Subject: RE: Complaint Received - Linden Road - Winter Gardens (Lakeside Community

Linden Road, Lakeside

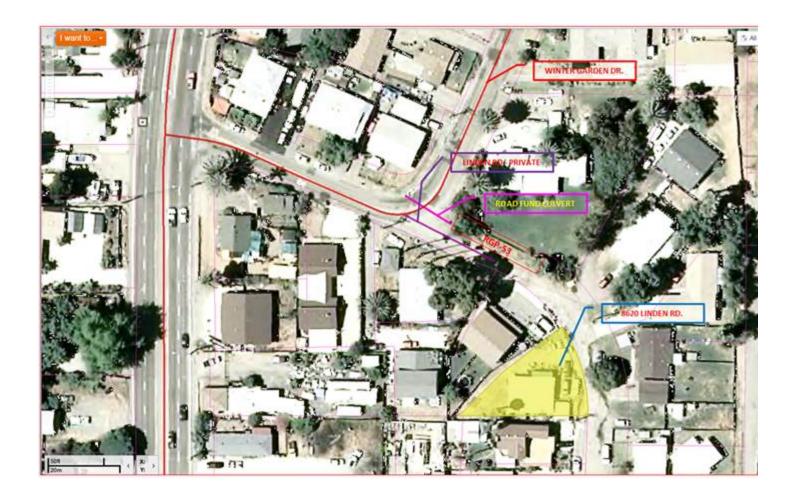
The map below shows the flow from Winter Gardens Blvd. (to the left) down the first segment of Linden Rd. where a culvert drains into the Flood Control ditch. The surface flow continues down the private (not accepted into the County system) road. Sediment does not enter the MS4. The purple line shows where the private segment of Linden Road begins and starts to deteriorate due to lack of maintenance by the responsible property owners.
